SCOPE OF PROJECT CHANGES:

PERMIT DRAWINGS

CLARKSON RESIDENCE

1 WALL SECTION @ ENTRY
1/2" = 1'-0"

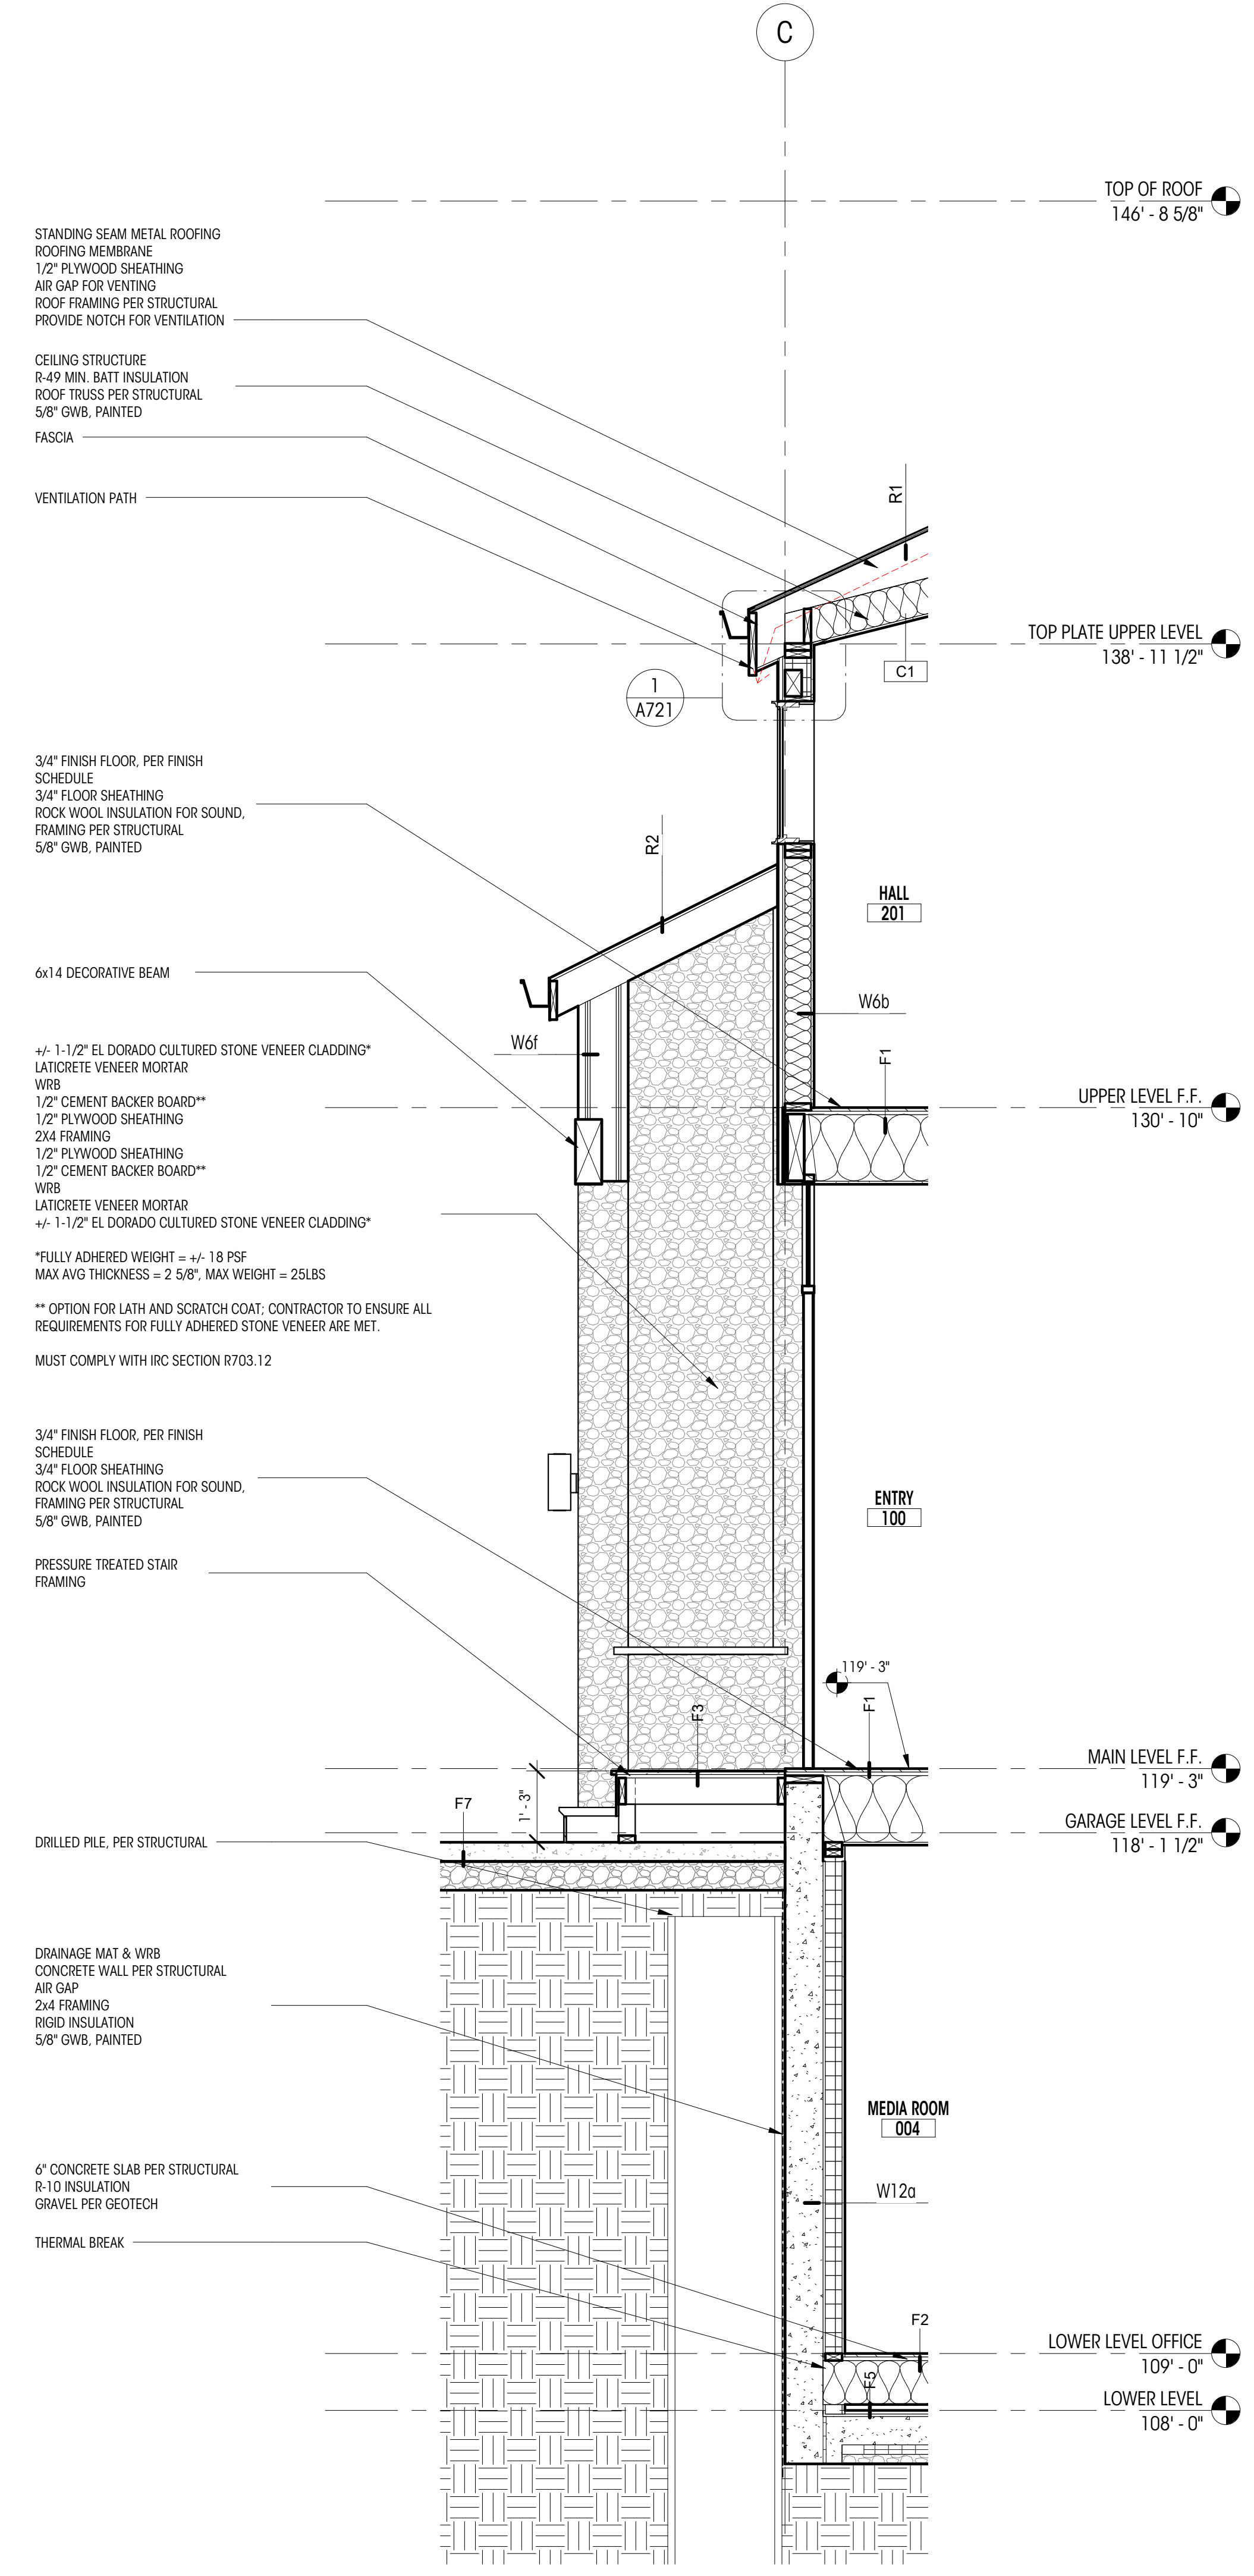
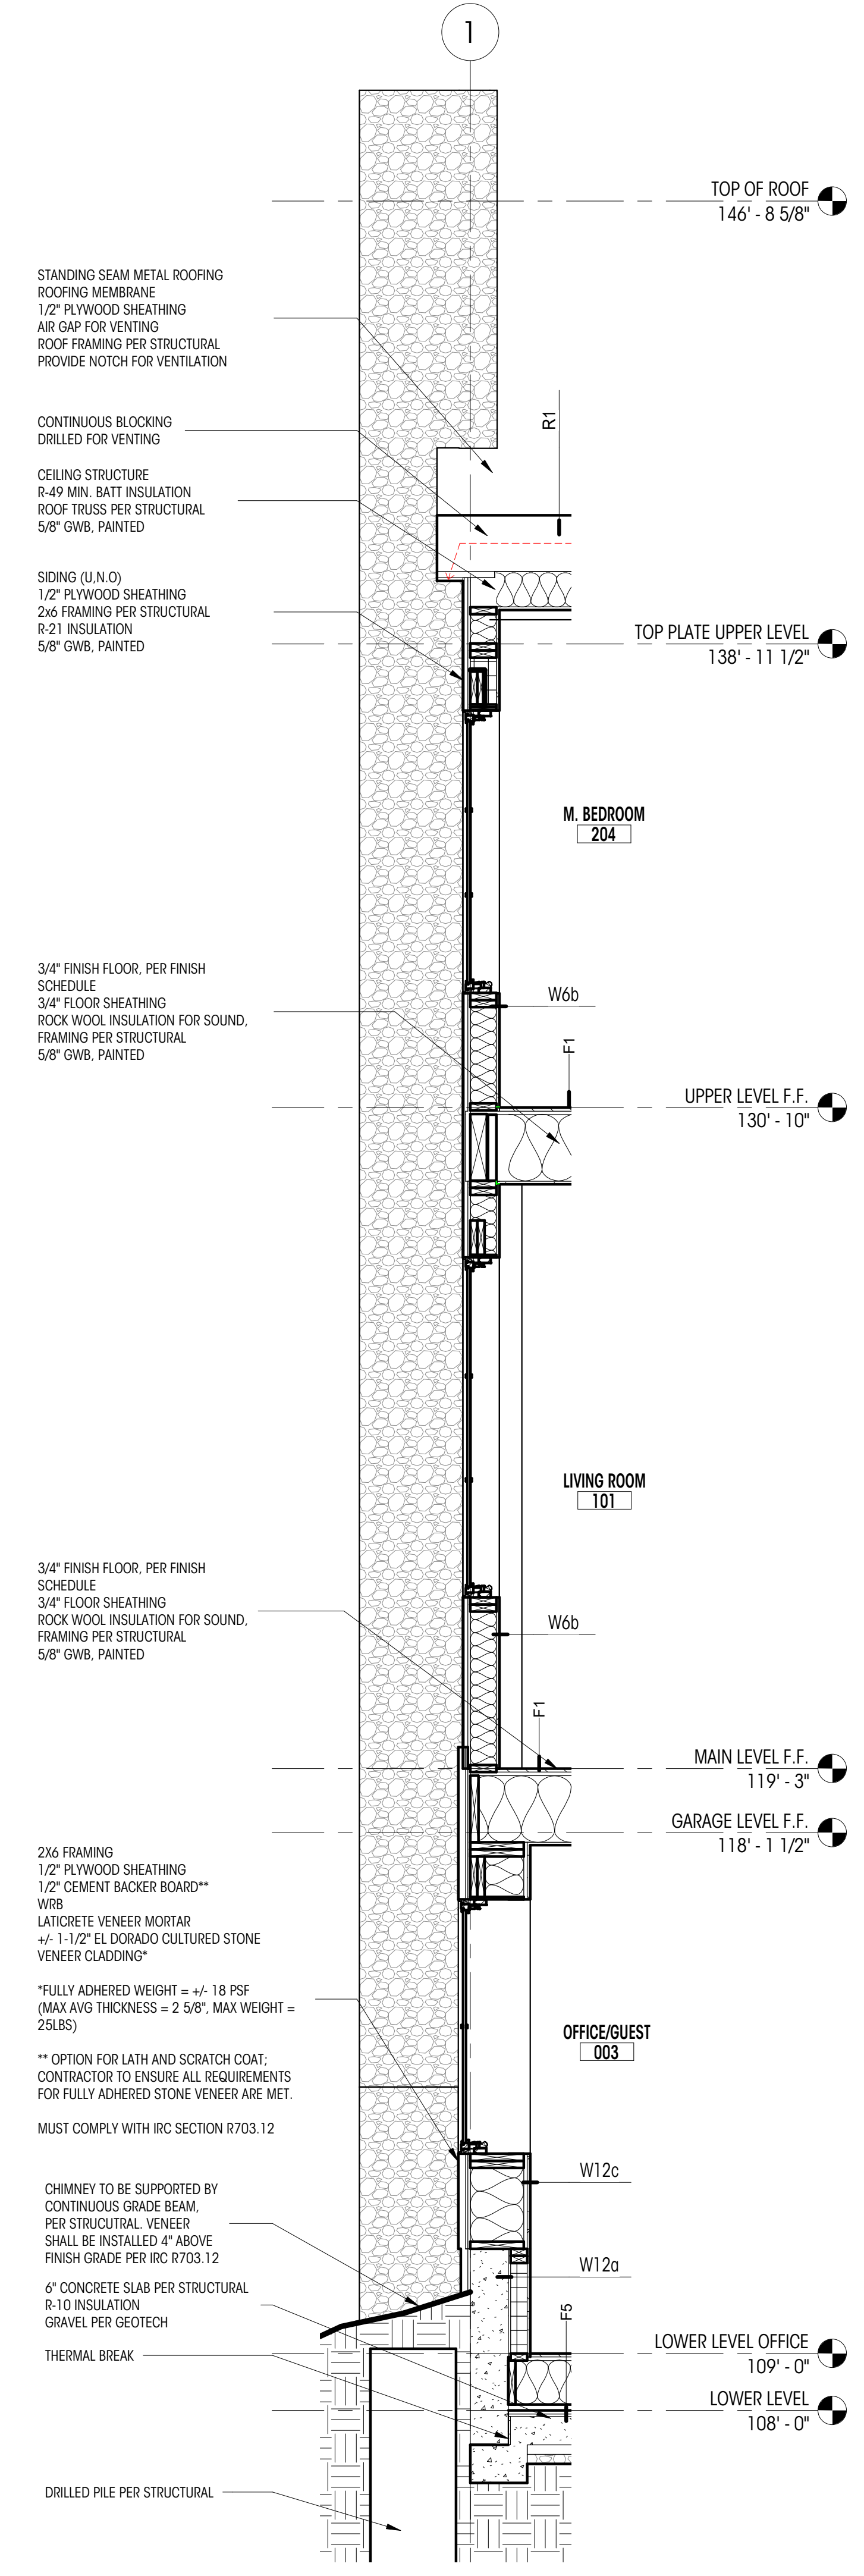
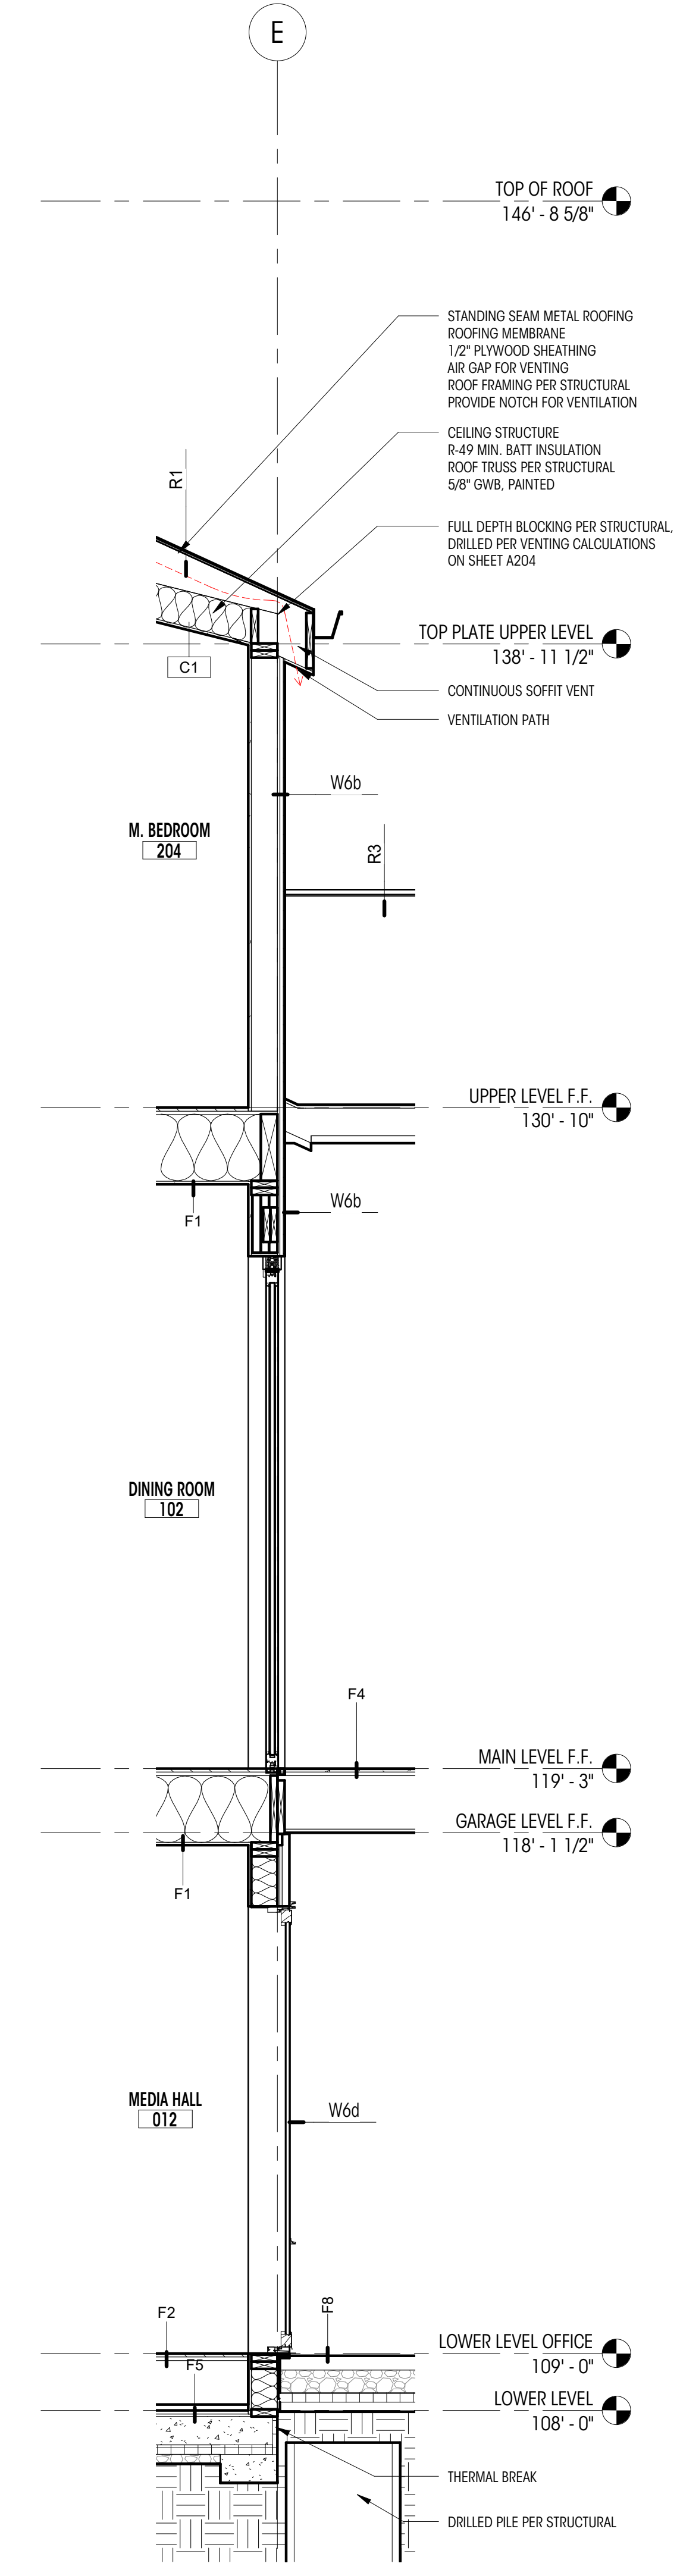
- ENTRY DESIGN CHANGE
- LEVEL CHANGES:
 - a. DRIVEWAY & GARAGE LEVEL DROP BY 15"
 - b. BASEMENT LEVEL DROP BY 12"
 - c. UPPER LEVEL DROP BY 2"
 - d. FRAMED FLOOR 12" ABOVE BASEMENT FLOOR.
 - e. CHANGE TO ABE AS A RESULT OF EXTENDED GARAGE AND EXTENDED COVERED DECK
 - f. CHANGE TO MAX HEIGHT AS A RESULT OF THE ADJUSTMENT TO THE ABE.
 - g. TOP PLATE LEVEL ADJUSTED UP BASED ON ROOF FRAMING
 - h. ROOF OF ROOF HAS LOWERED AS A RESULT OF REDUCED ROOF PITCH.
